**RE: IRONWOOD RIDGE SUBDIVISION (K11-D11). REQUEST FOR SITE
DEVELOPMENT PLAN AND BUILDING PERMIT APPROVAL. ENGINEERS
STAMP DATED OCTOBER 3, 1997.**

GRADING AND DRAINAGE PLAN REVISION

TRACT A

GRADING AND DRAINAGE PLAN REVISION
TRACT A IRONWOOD RIDGE SUBDIVISION

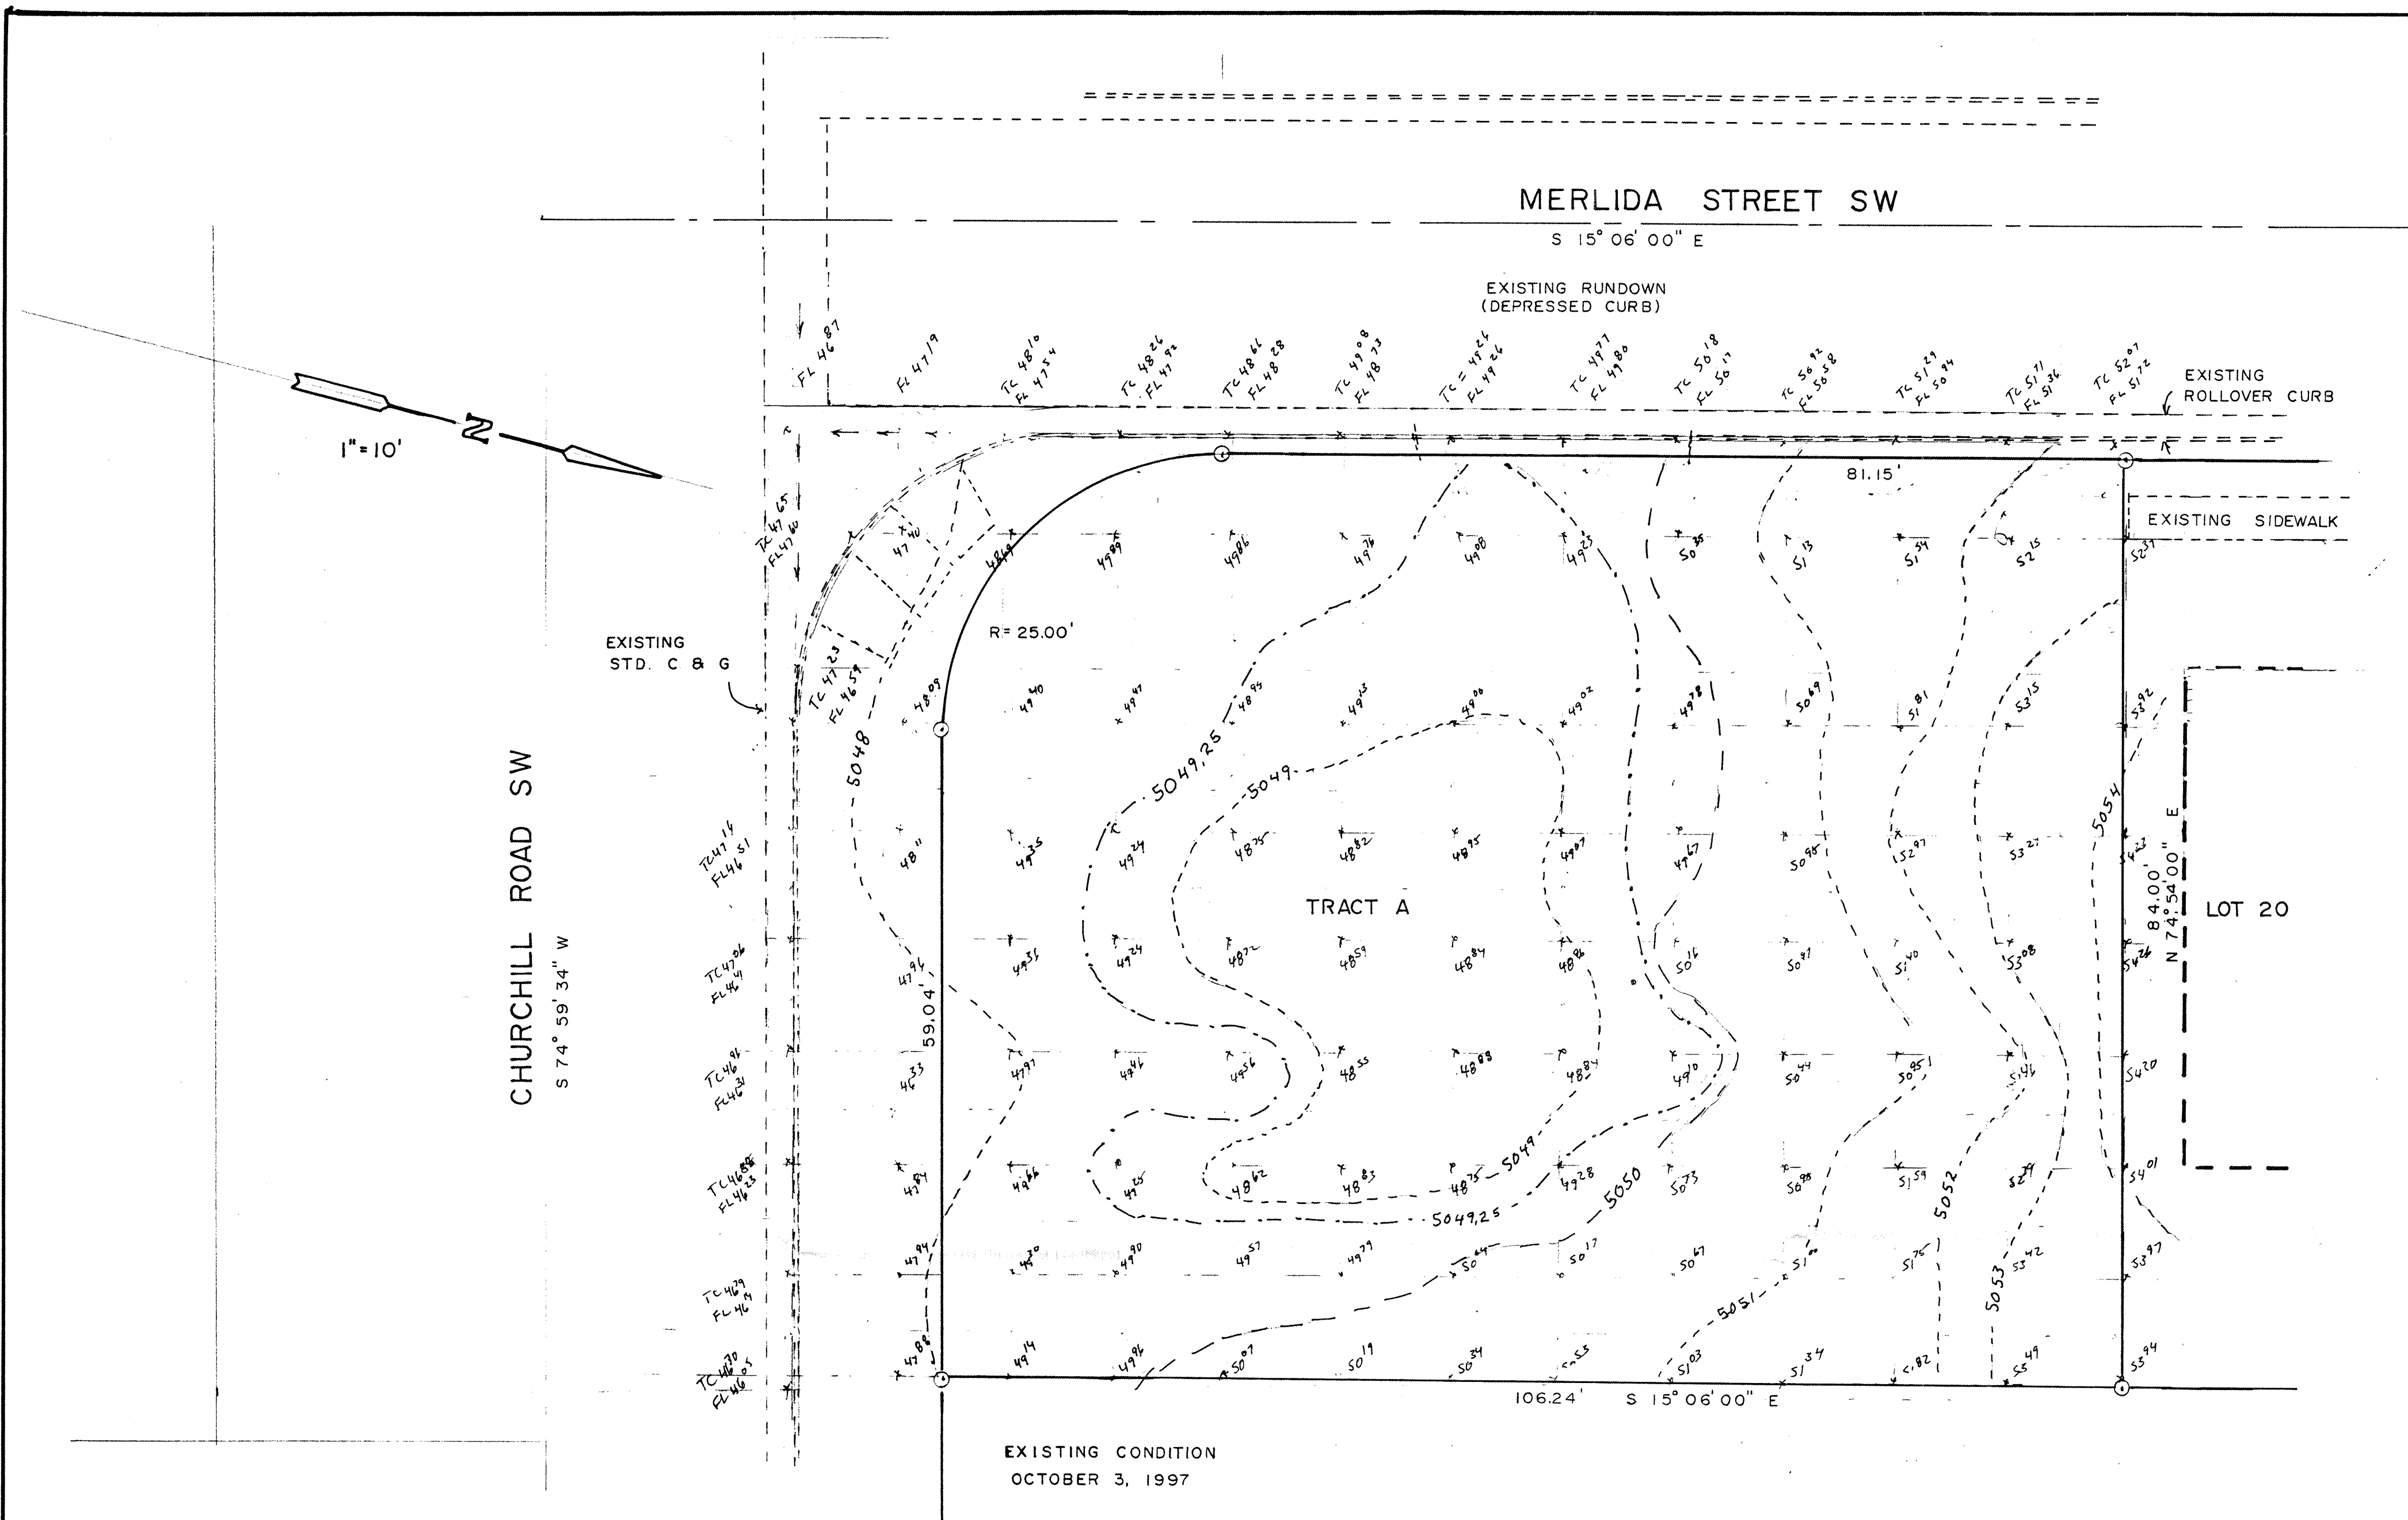
*You just said
the inlet was
in place?*
